ADDENDUM #2

Coastal Carolina Community College
Learning Resources Center
First Floor Renovation
SCO ID: 23-26060-01A

12.13.24 ADDENDUM #2: City of Jacksonville review comments

Sheet No. G1.1

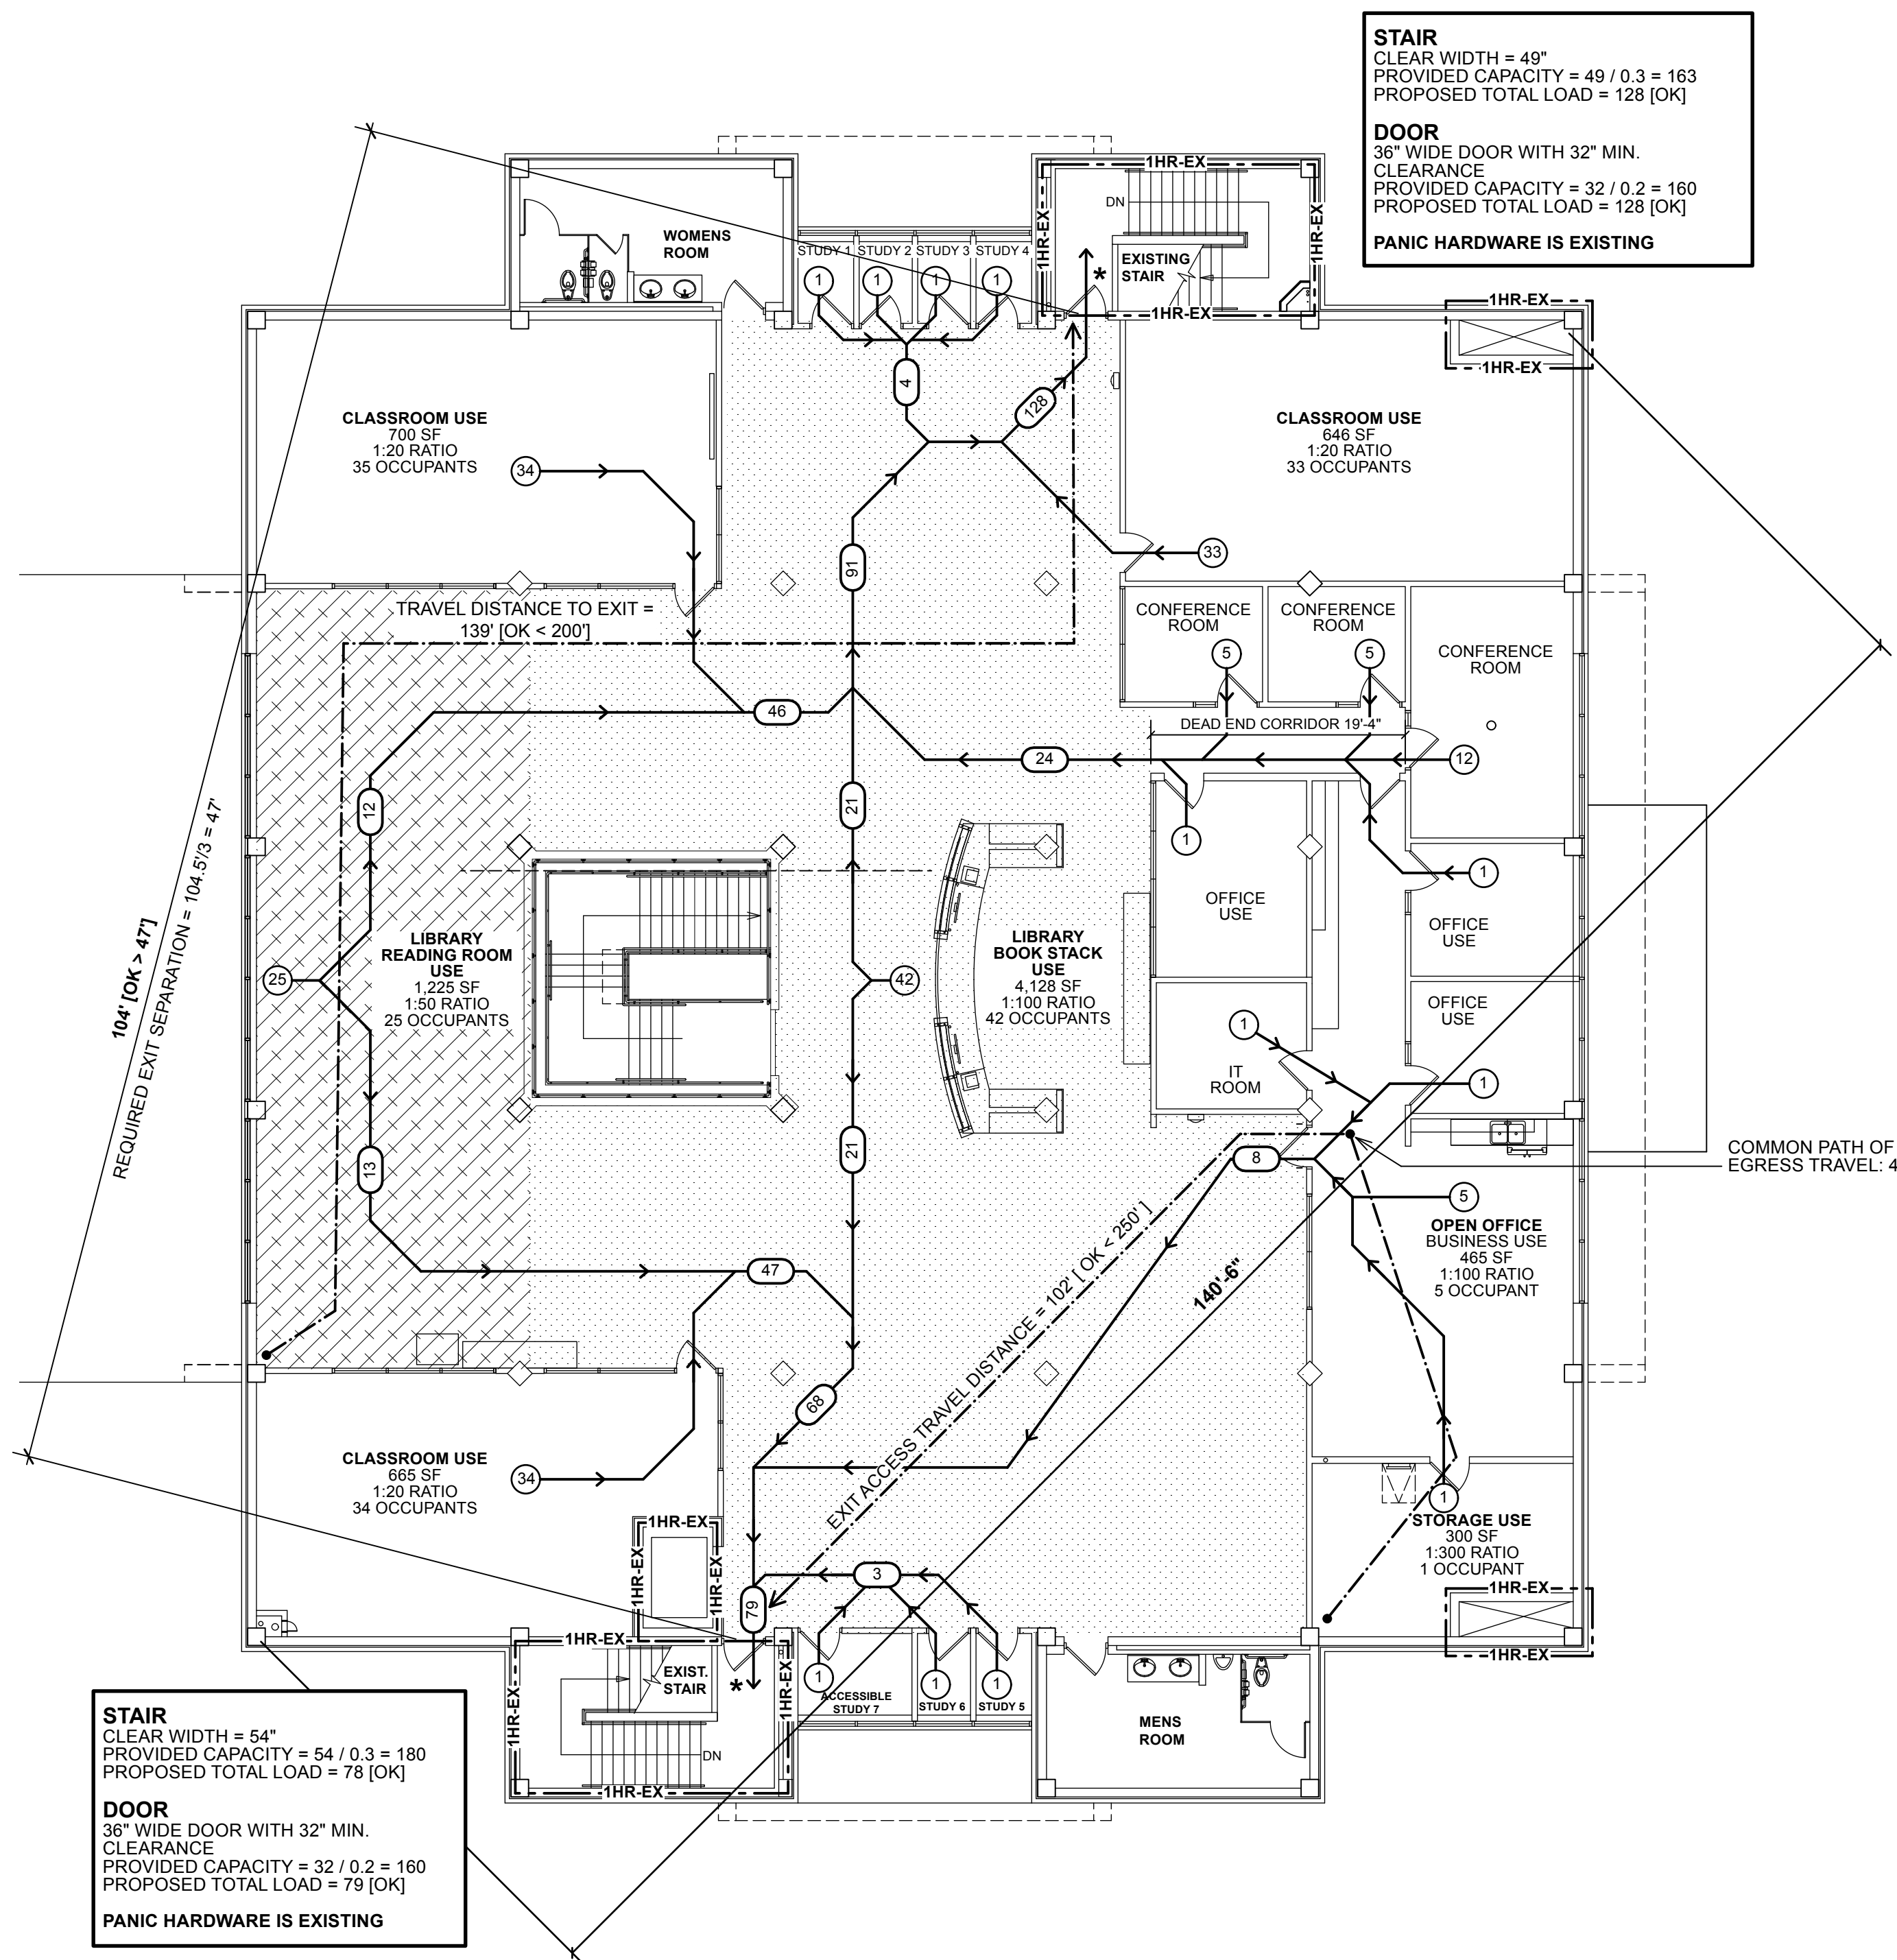
There was a minor mathematical error recorded on sheet G1.2 for the total first floor occupant count. Architectural drawings G1.1 and G1.2 have been revised and submitted to the City of Jacksonville. Revised drawings are included as **Attachment #3 and #4.**

E-0.9
 Addendum #2
 Attachment #6

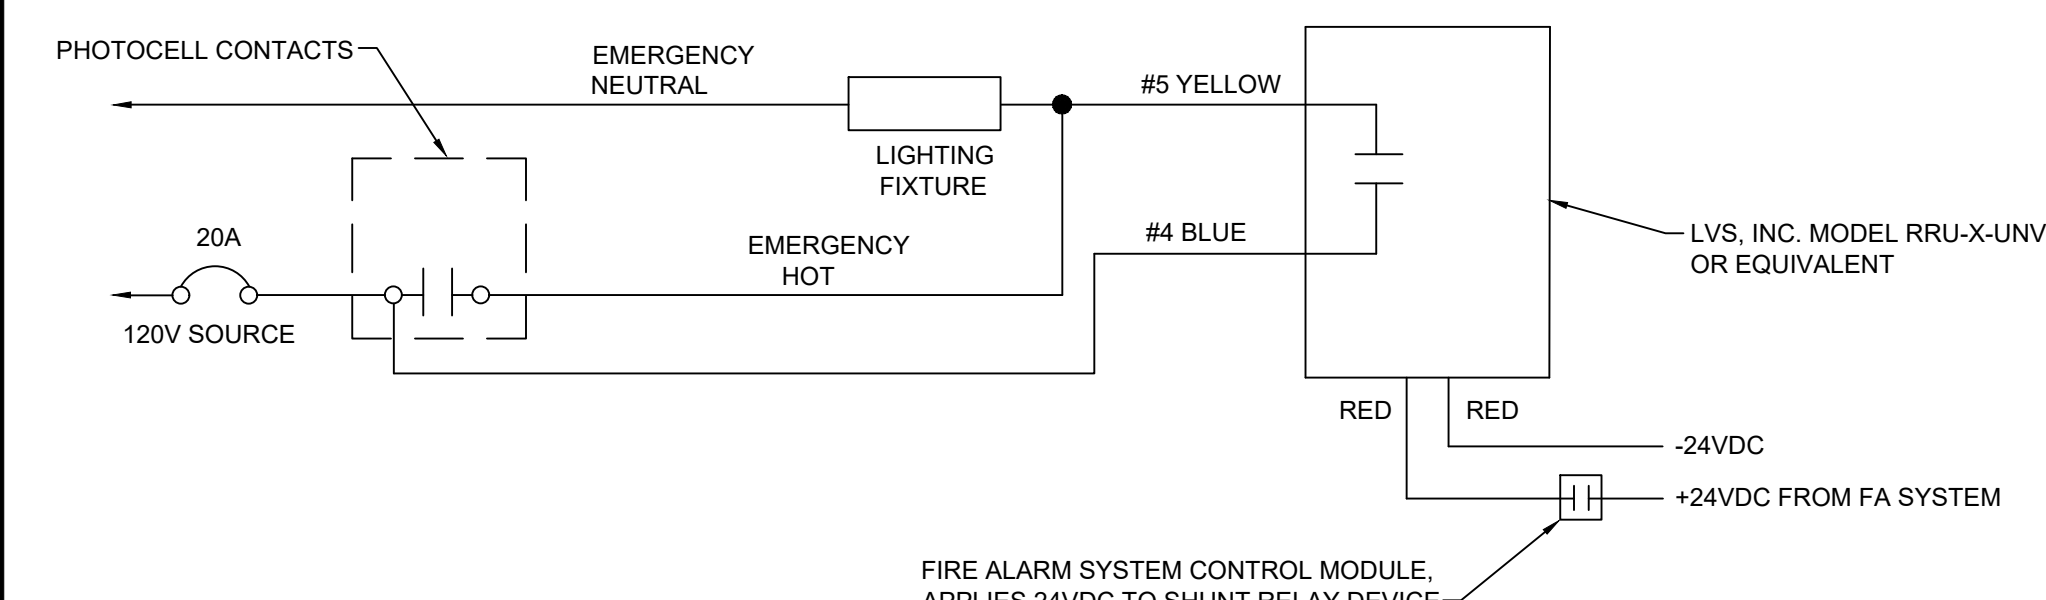
The specified exterior lighting fixture types L12 and L12E have a B.U.G. rating of U=0. The Lighting Fixture Schedule has been revised to indicate this requirement. Revised drawing sheet E-0.9 is included as **Attachment #6.**

REMARKS:
 1. BI-LEVEL SWITCHING
 2. DAMP LOCATION
 3. WET LOCATION
 4. WIREGUARD
 5. LED REQUIRED SURGE PROTECTION
 6. FINAL COLOR SELECTION BY ARCHITECT
 7. AR TRIM, TRW TRIM, MWD DIST.
 8. NOT USED
 9. NOT USED
 10. TILT/ABLE STAND
 11. 0-10V NON-DIMMING DRIVER, RATING AS REQUIRED BY LOAD
 12. 0-10V DIMMING DRIVER(S), RATING AS REQUIRED BY LOAD
 13. END FEED BARE WIRE CONNECTION
 14. FACTORY ASSEMBLED
 15. FIELD ASSEMBLED
 16. PROVIDE 90 MINUTE BATTERY BACKUP FOR 100% FIXTURE OUTPUT
 17. LIGHTING FIXTURE MUST BE PROVIDED WITH B.U.G RATING OF U=0.

Sheet No.
F0.1
Addendum #2
Attachment #7

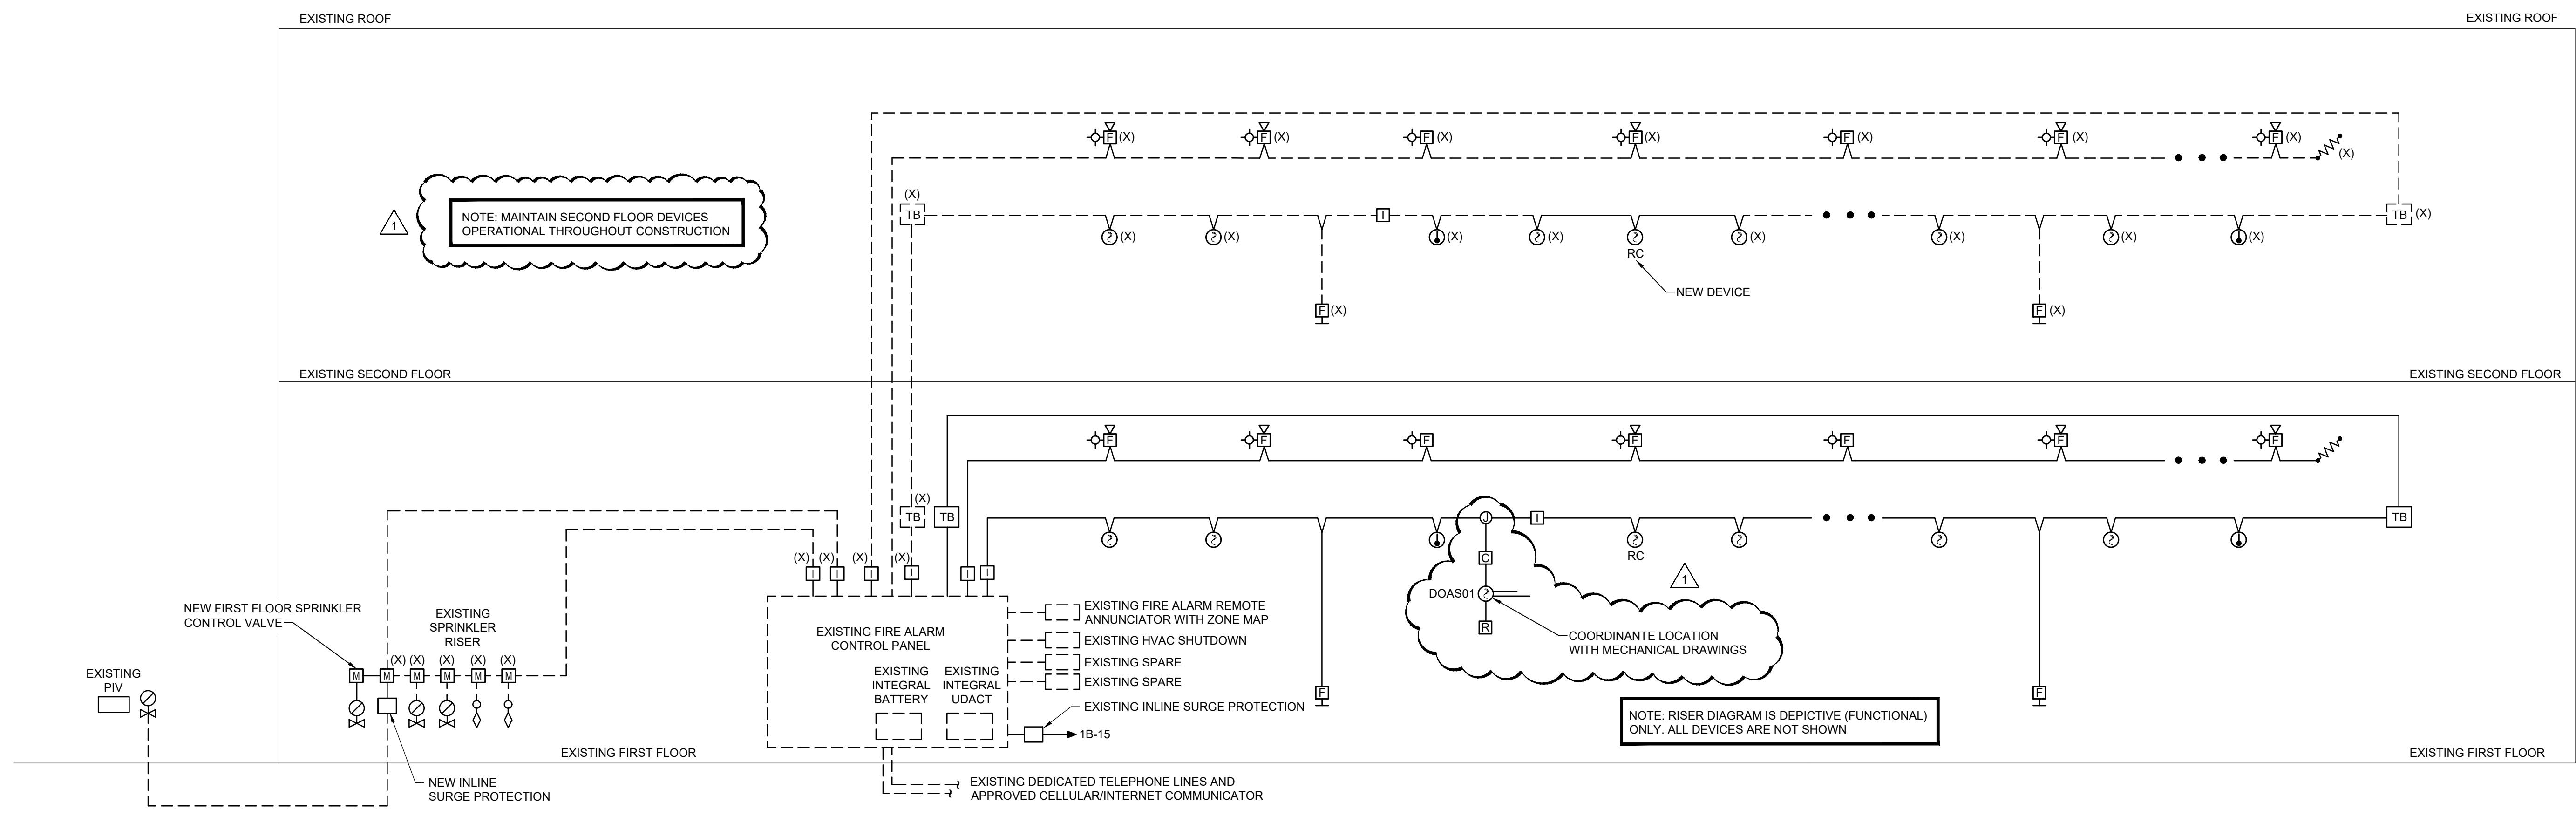
Drawing sheet F0.1 has been revised to include a requirement for Fire Alarm Shop Drawings and a Fire Construction permit application to be submitted to the City of Jacksonville during construction. Revised drawing sheet F0.1 has been included as **Attachment #7.**

E1 FIRST FLOOR PLAN - FIRE ALARM
1/8" = 1'-0"

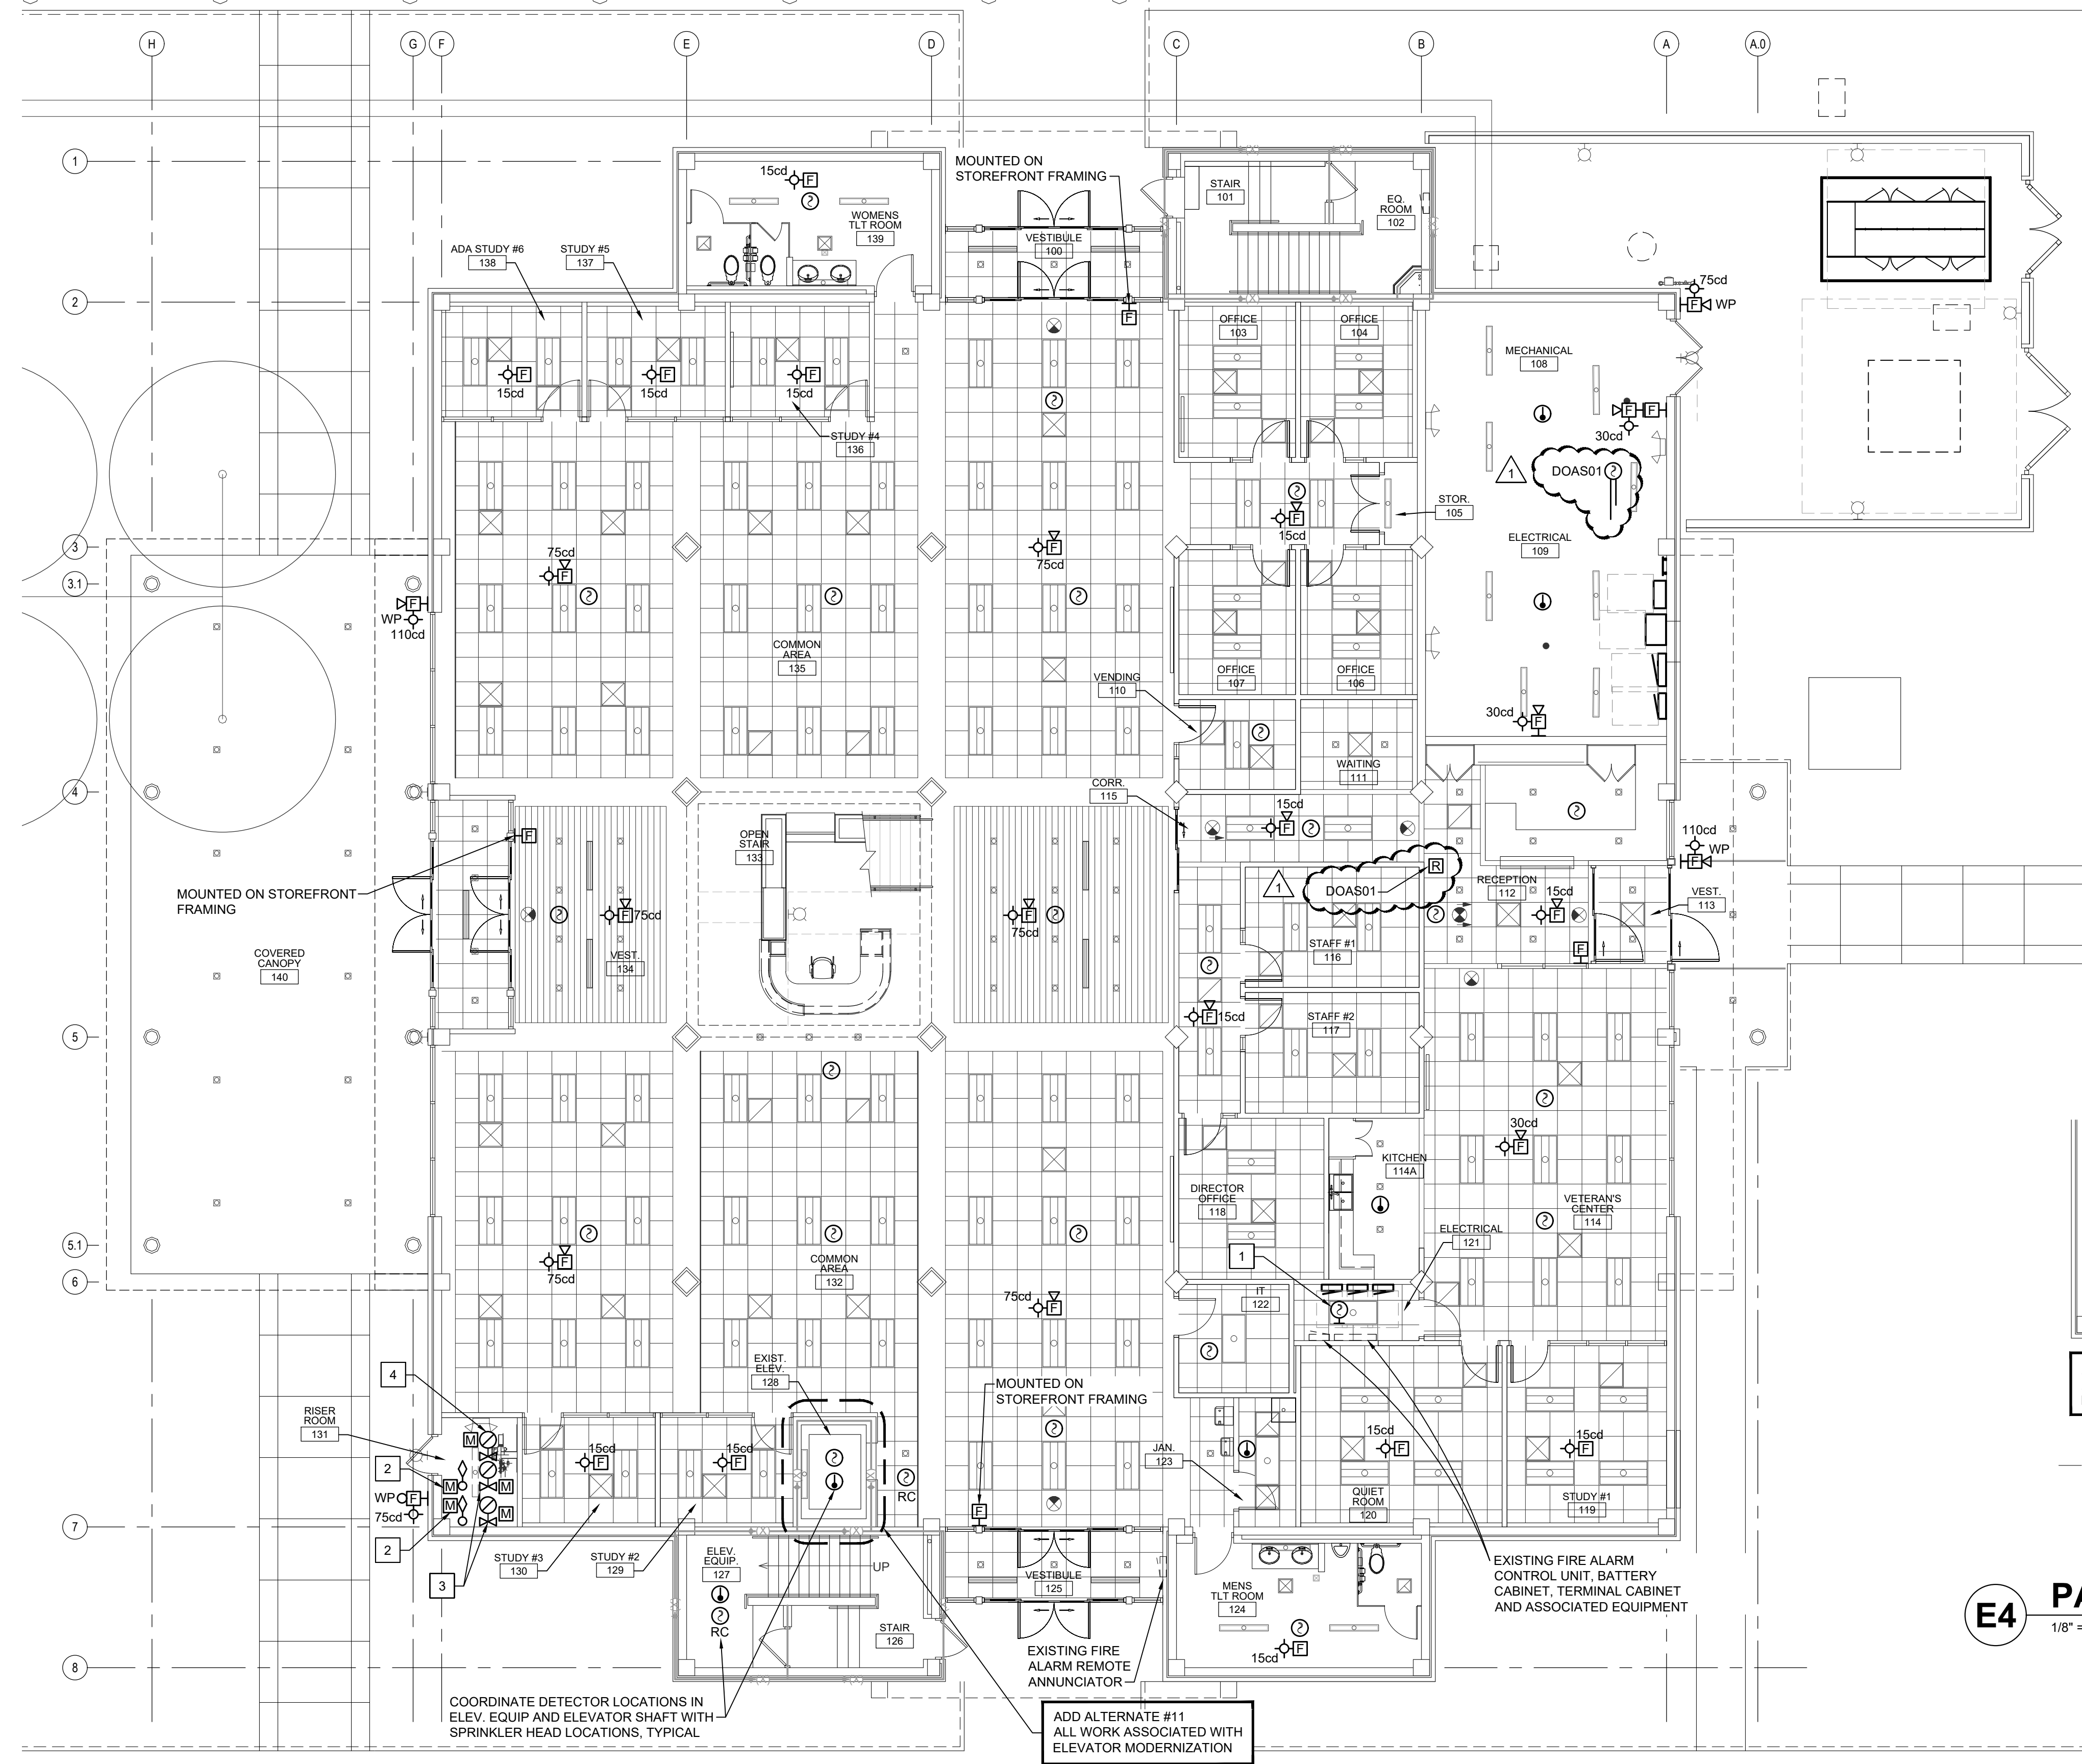
The Fire Alarm System Control Matrix has been modified to include elevator recall initiated by smoke detection. Revised Sheet F1.1 has been included as **Attachment #8.**
